ADDENDUM No. 3
FOR
LINK – Multi-Use Development
BID PACKAGE – All Trades

Date of Issue: April 24, 2023

LINK – Addendum #3 Narrative

4/21/23

6 UNIT 0F
S151 1/4" = 1'-0"

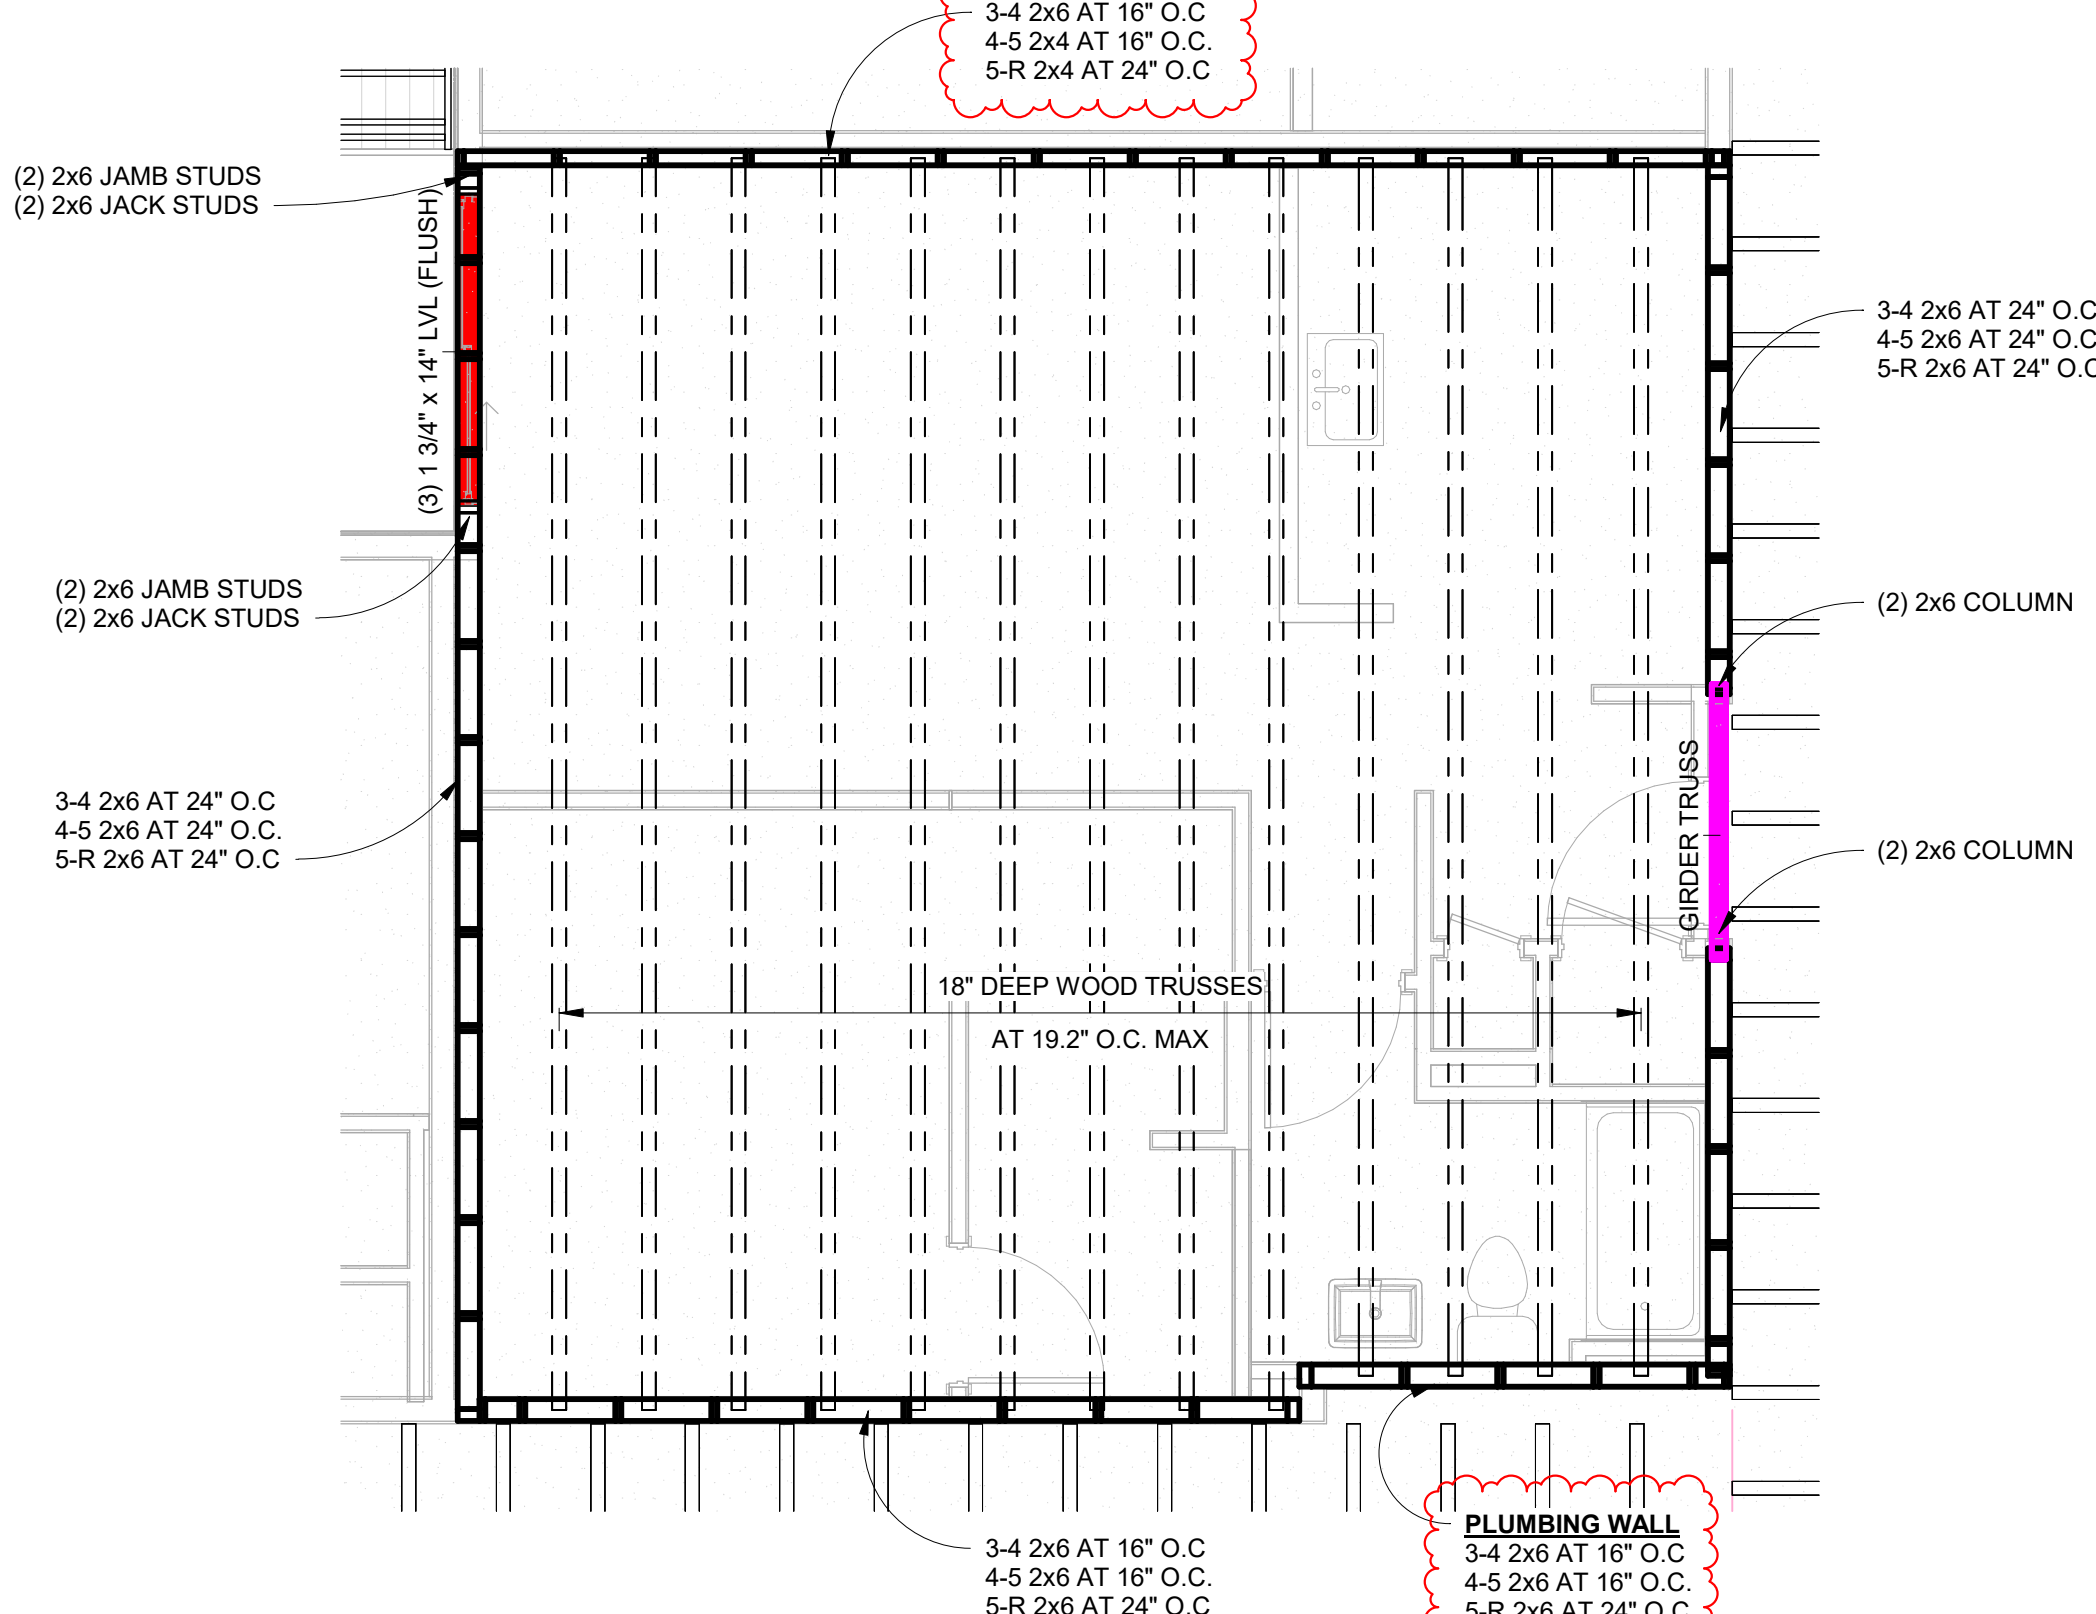
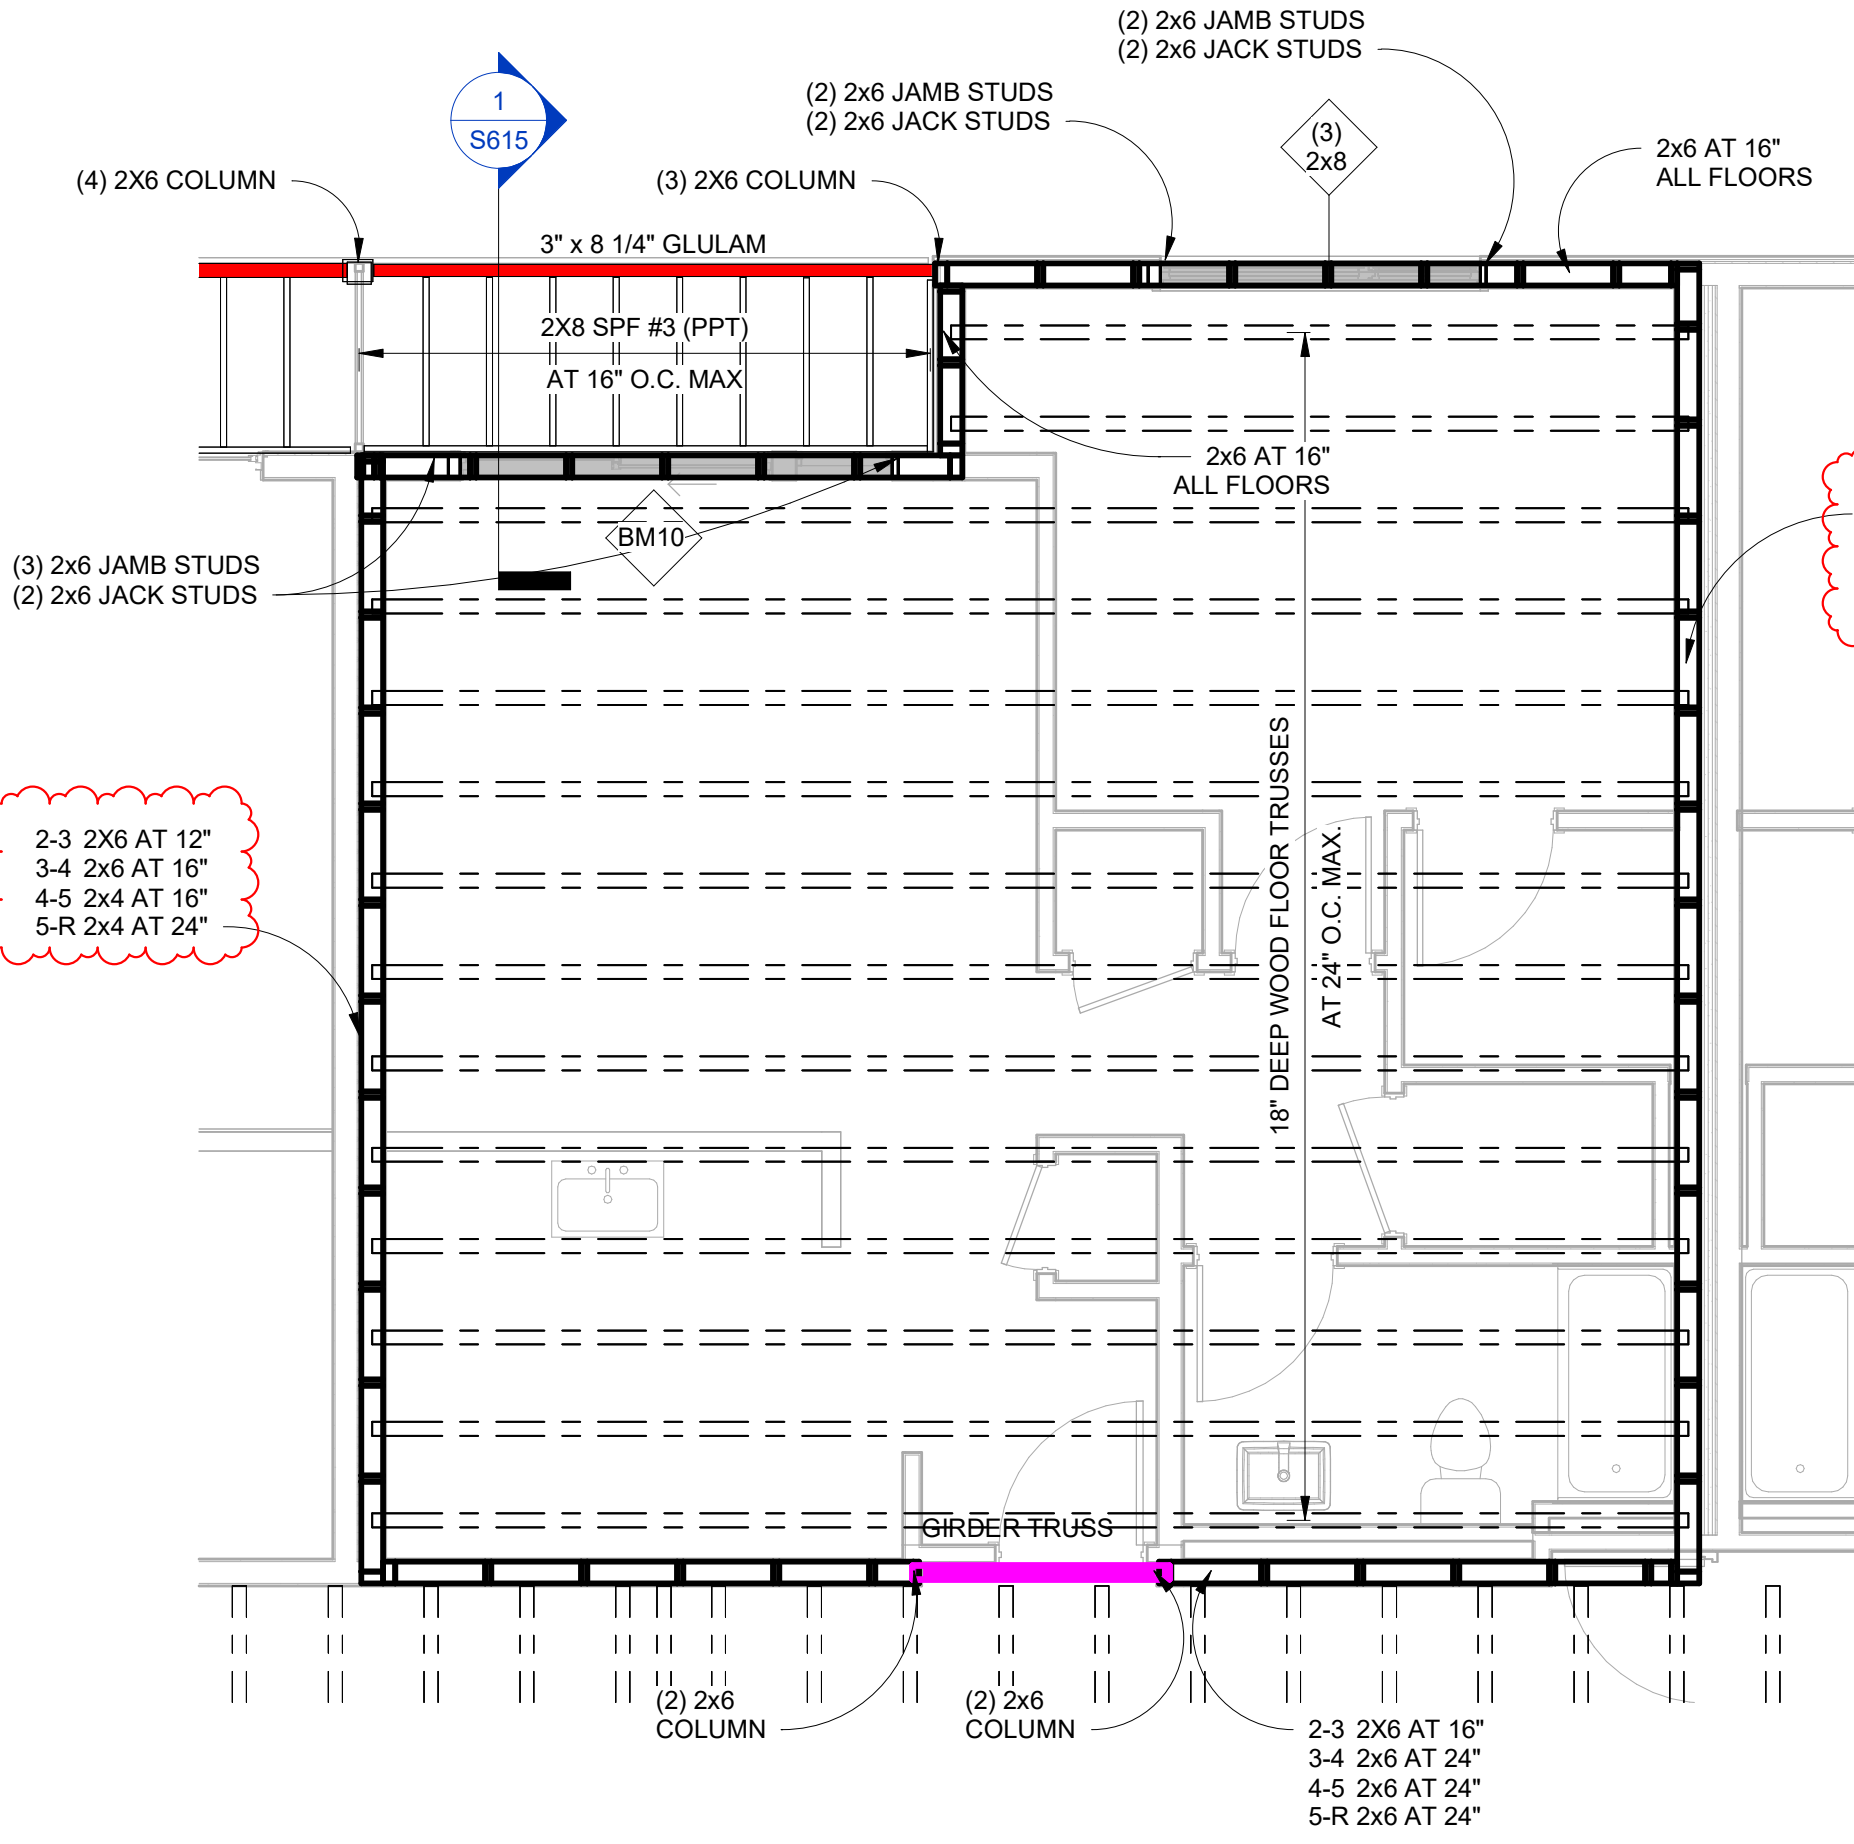
- S150
 - Revised studs at upper floor demising walls to 2x4 studs where indicated.
 - S151
 - Revised studs at upper floor demising walls to 2x4 studs where indicated.
